Applicant:	South Loop Investments, LLC (owner/applicant)
Location:	8100 26th Avenue South
Request:	Final Development Plan for a 8,040 square foot, 271 indoor and 80 outdoor seat restaurant and a 3,416 square foot retail building within the Alpha B planned development
Existing Land Use and Zoning:	Hotel / vacant land; zoned LINDAU MIXED USE (LX)
Surrounding Land Use and Zoning:	East—Offices; zoned CO-1(AR-17) North—Hotel; zoned LX(PD)(AR-17) South—Surface parking lot; zoned CO-2(PD)(AR-17) West—Mall of America; zoned CX-2(PD)(AR-17)
Comprehensive Plan Designation:	Lindau Mixed Use

## PROPOSAL

Approved PDP

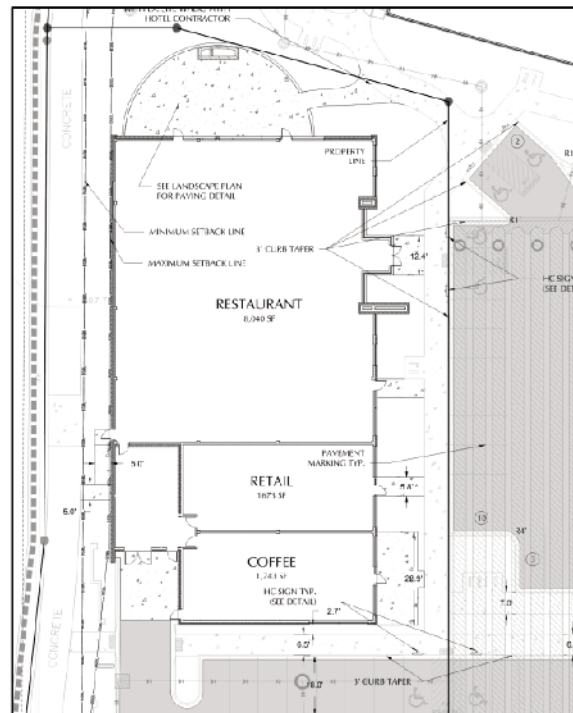
The general configuration and development intensity was approved through the Alpha B PDP. The Phase 2 building that was depicted in the PDP is below on the left. The proposed Phase 2 building is shown below on the right. Apart from swapping some restaurant space for speculative retail space, and minor changes to primary building entrances, the overall building size and configuration of Phase 2 has remained the same. The FDP is consistent with the PDP.
